ADDENDUM

NO. 3

PROJECT NAME: Lehman High School 2025 Additions and Renovations

ADDENDUM DATE: 14 May, 2025

PACKAGE	VOLUME
Job No. 01954-08-01	Sheet No. ISSUE FOR BID
Drawn By: RAU	C2.01
Date: 05/15/2025

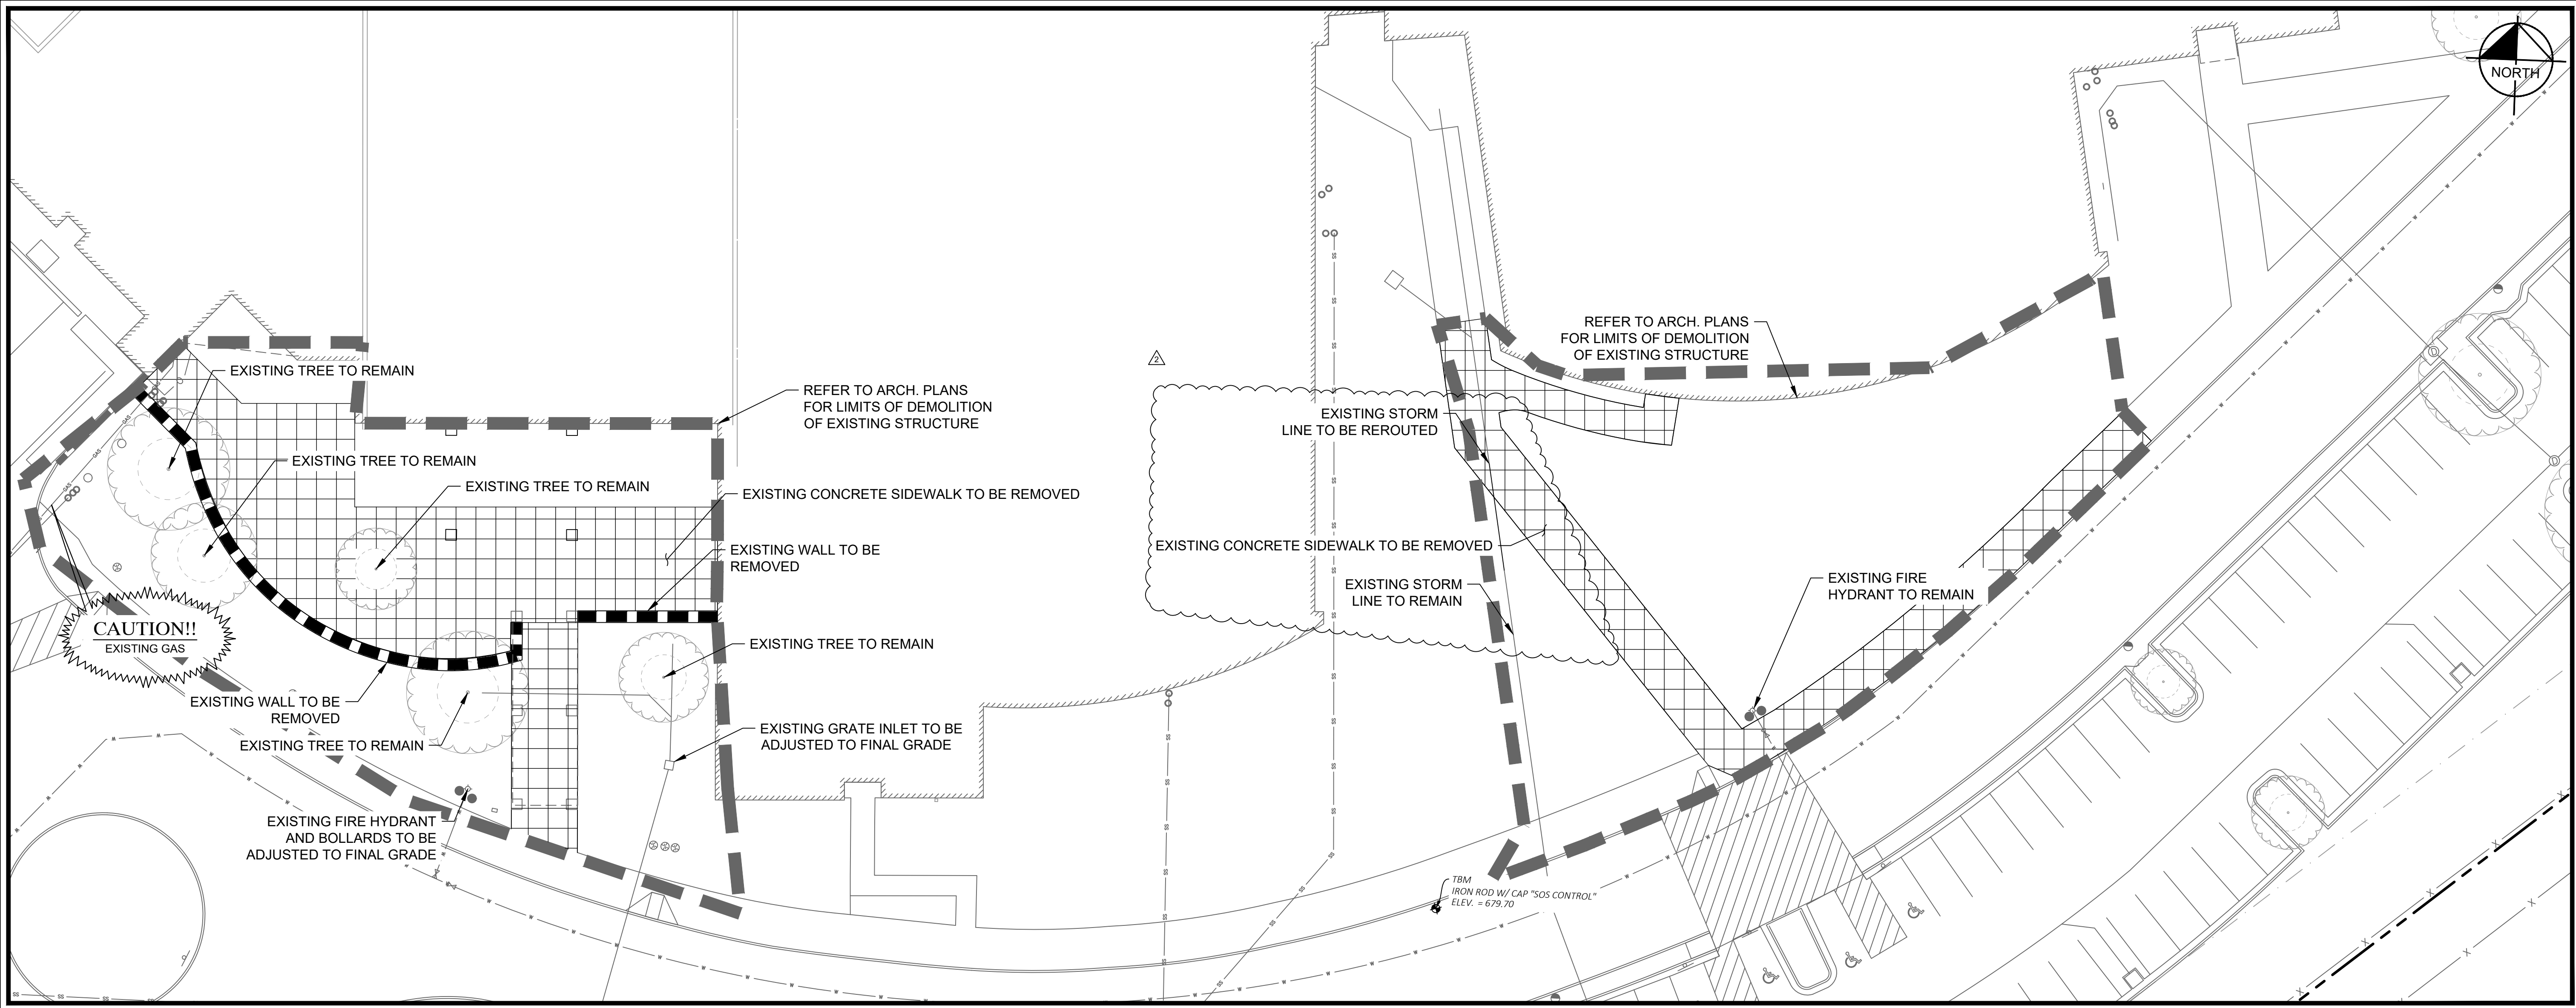
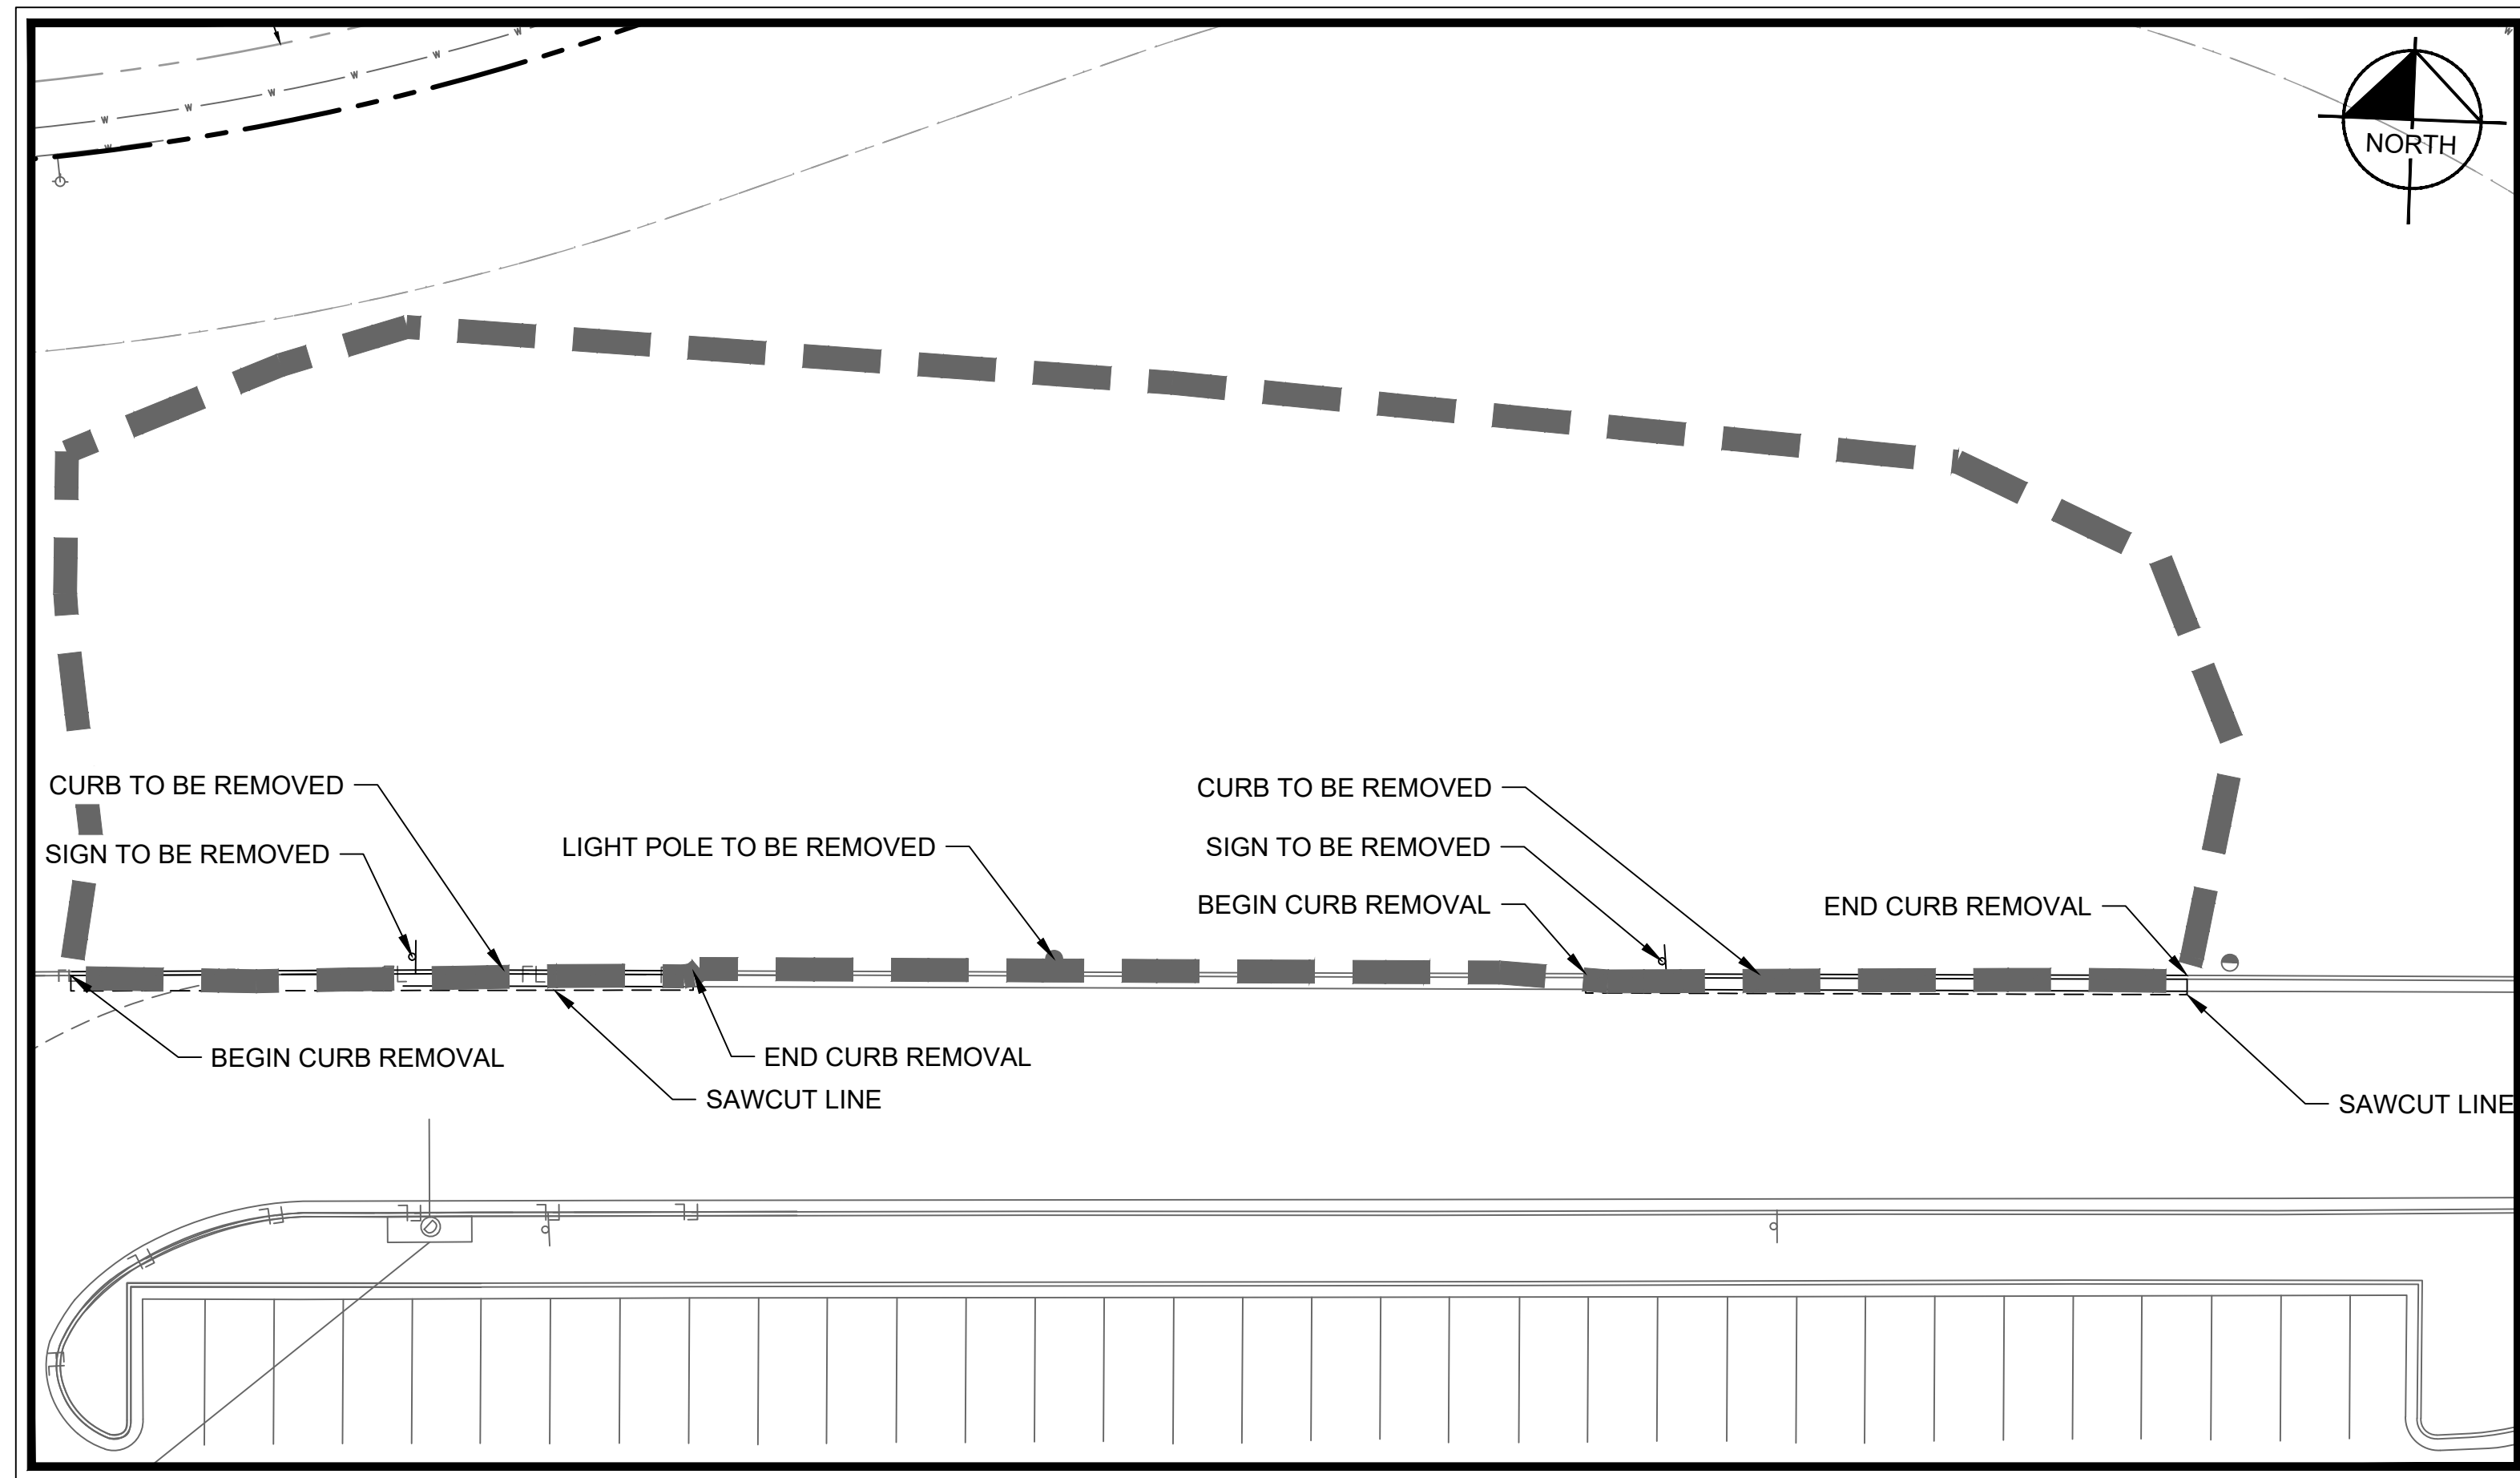
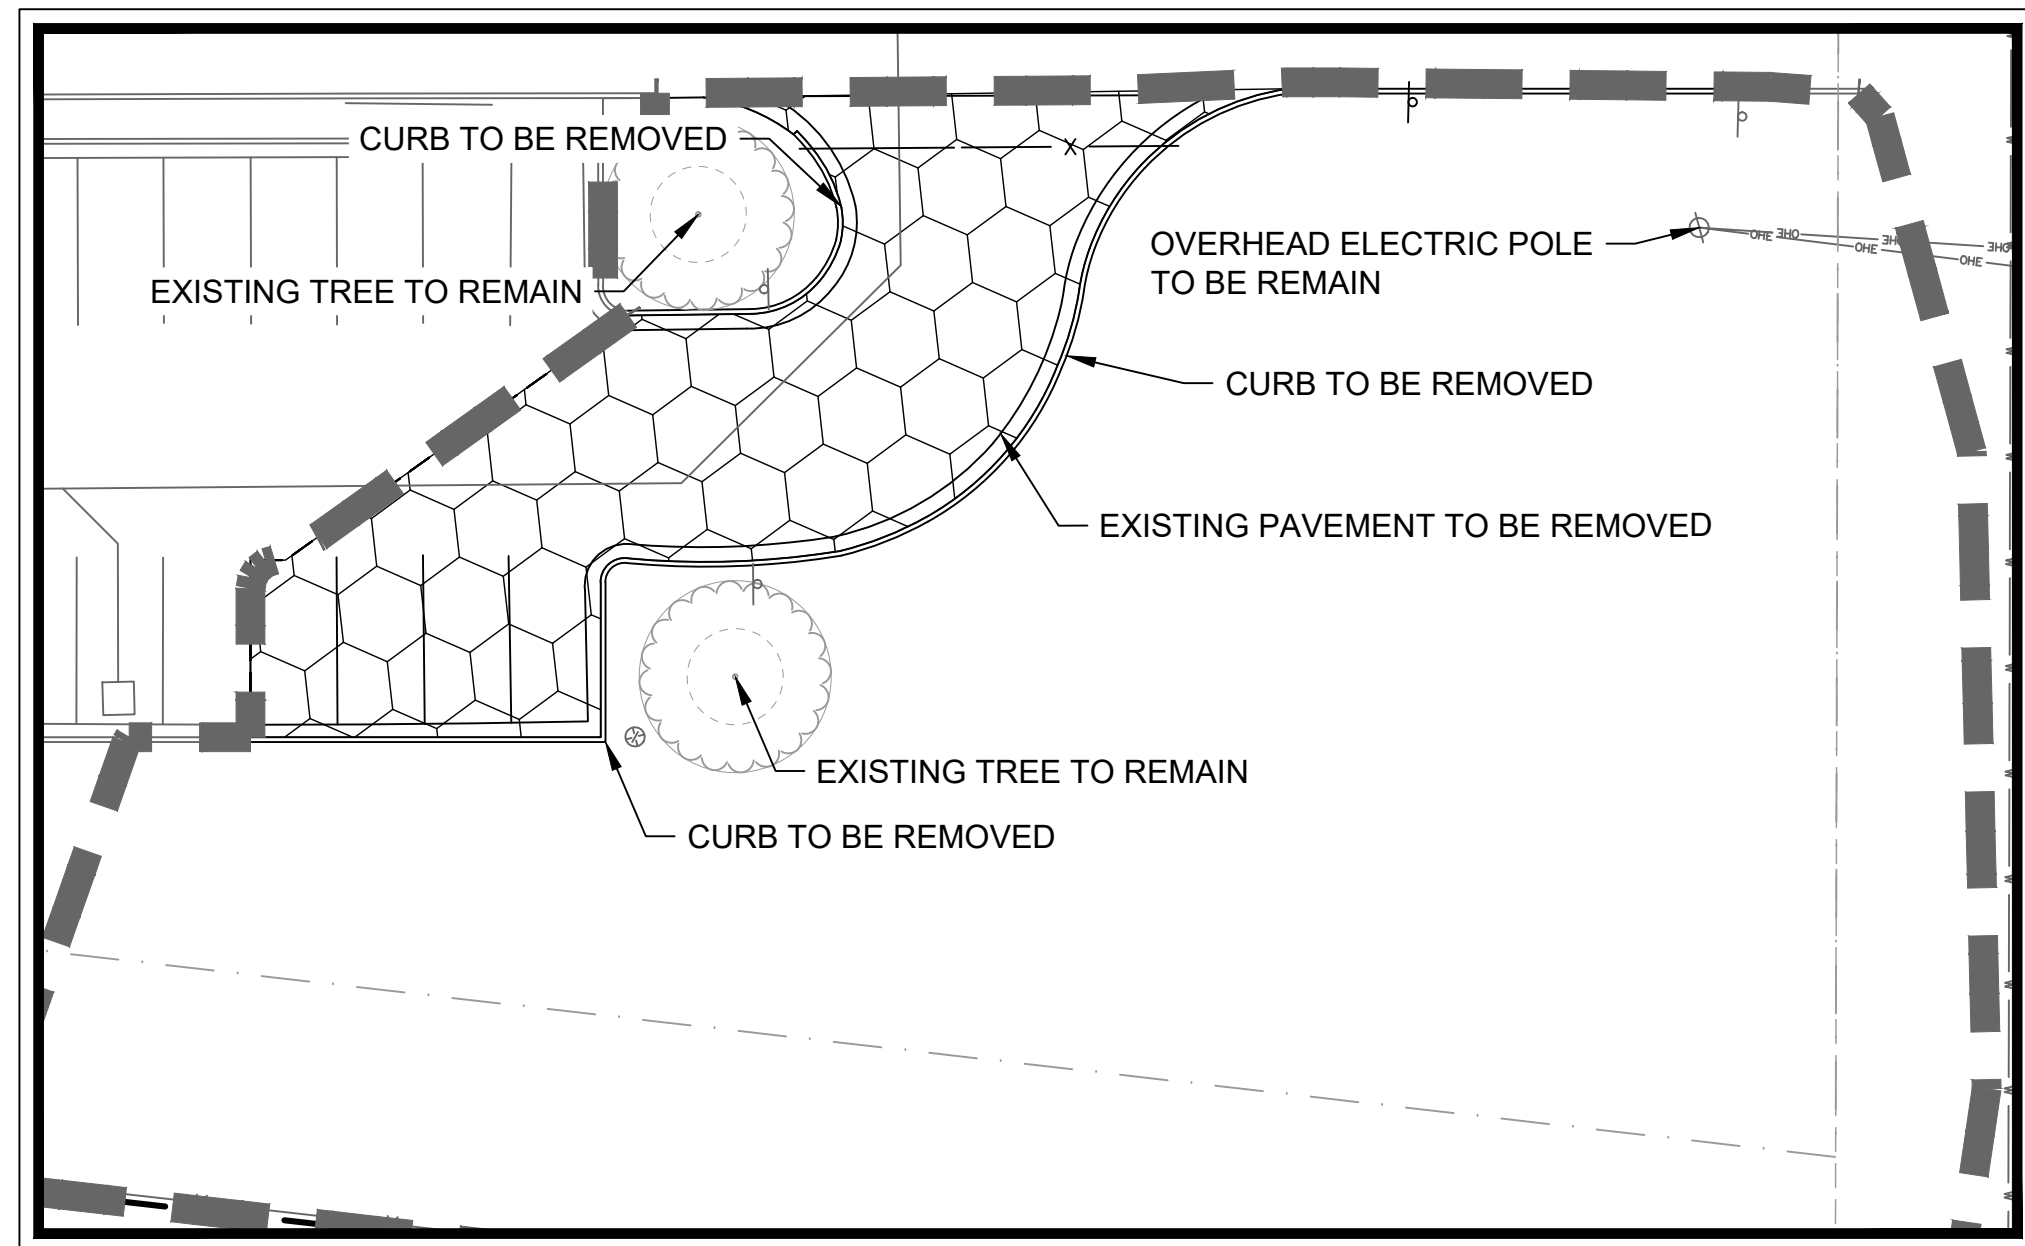
- 1) Reroute of storm line.
